# Service Bulletin

CB1000 #1

## SAFETY RECALL

### 2025 CB1000SP GEAR SHIFT PEDAL PIVOT BOLT

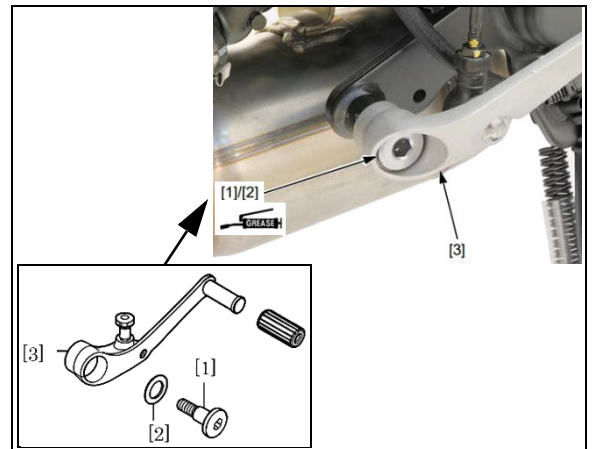
1. Remove the gearshift pedal pivot bolt [1], wave washer [2], and gearshift pedal [3].

**IMPORTANT:** The wave washer [2] will be reused, do not discard.

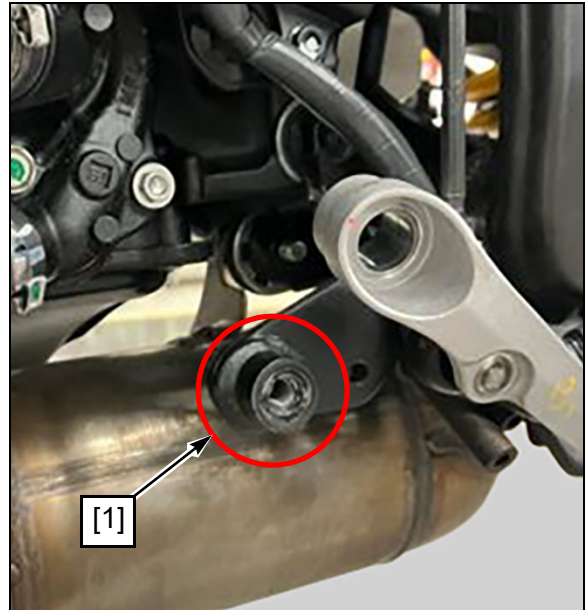
3. Remove the paint from the frame on the circular end where the shift pedal mounts.

- a. Polish the bolt seating surface [1] with #40 ~ #80 sandpaper by moving the block in only a circular motion until there is no paint on the bolt seating surface.

- Apply light to moderate pressure on the sandpaper block to allow the sandpaper to remove the paint but not remove any metal from the frame.
- Do not use a power tool to remove the paint to prevent damage to the frame.
- Do not use a chemical agent to remove the paint.
- Do not touch other parts with sandpaper to avoid damage.
- Set the block parallel to the bolt seating surface to remove paint equally.
- Do not sand in a linear motion to prevent uneven removal or possible grinding of the frame metal.

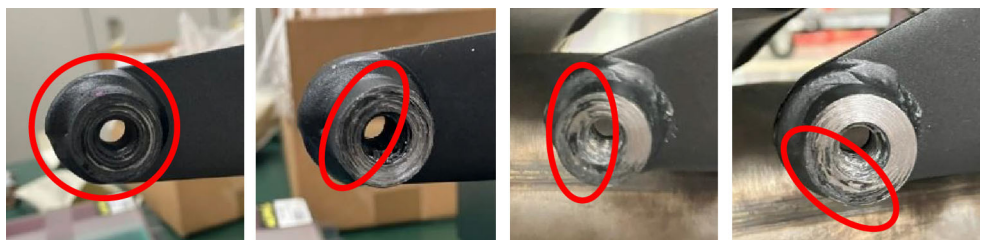
**GOOD**

The metal is completely clean and free of paint.

**NOT GOOD**

Paint is still visible on the frame and the surface is not smooth.

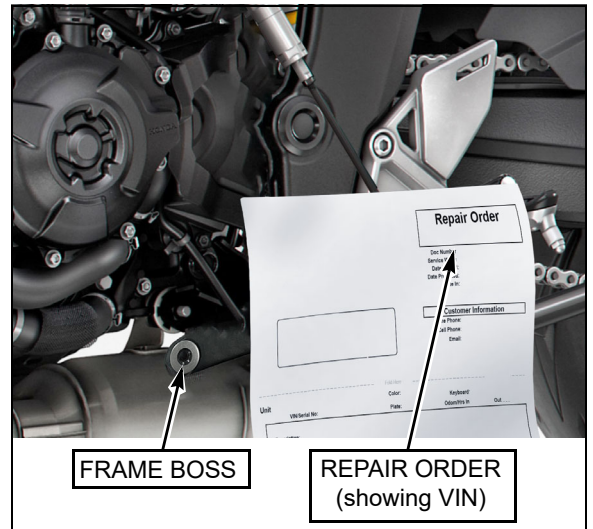
- 4. Take a photograph of the polished frame boss with the repair order showing the VIN.

This photograph **MUST BE** submitted by TechLine Connect. The purpose of this photograph is to ensure the frame boss was properly sanded to remove the paint.

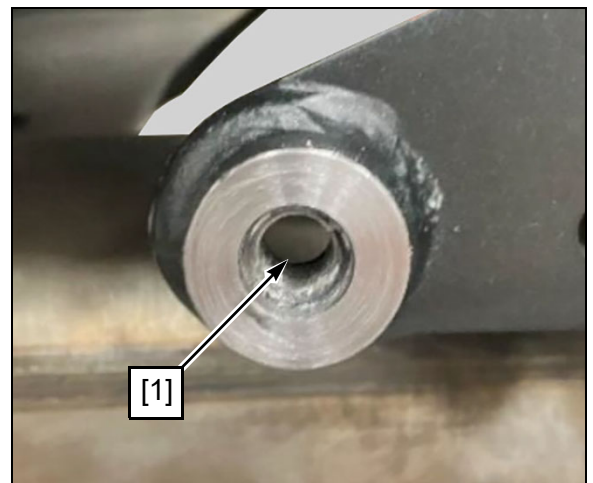
- a. Blow compressed air on the surface and in the screw hole [1] where the paint has been removed.
- b. Ensure the frame threads are carefully cleaned and degreased, using Pro Honda Contact/Brake Cleaner, before installing the gear shift pedal to the unit.

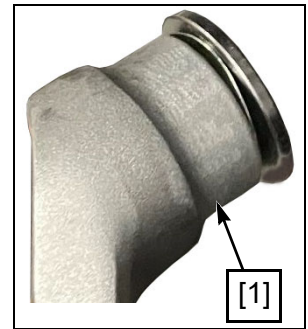
- c. Install the wave washer [1] to the new collar [2].
- d. Apply grease to the sliding part of the shift pedal [3].

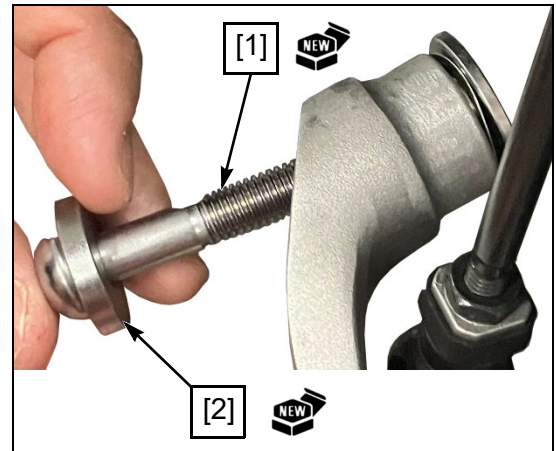
- e. Install the collar with wave washer onto shift pedal [1] from the side closest to the frame.

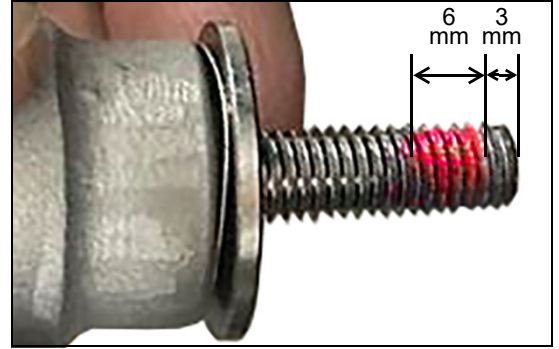
- f. Install the new bolt [1] and the new washer [2] to the shift pedal.

- g. Apply Hondalock 2 HT (medium strength) or equivalent on the bolt thread.

**NOTE:** Apply locking agent **after** installing the bolt to the change pivot collar.

- h. Apply the locking agent starting 3 mm from the tip of the bolt, covering a width of 6 mm.

- i. Tighten the change pedal pivot bolt to the specified torque.

**TORQUE:** 27 N·m (2.8 kgf· m, 20 ft-lb)
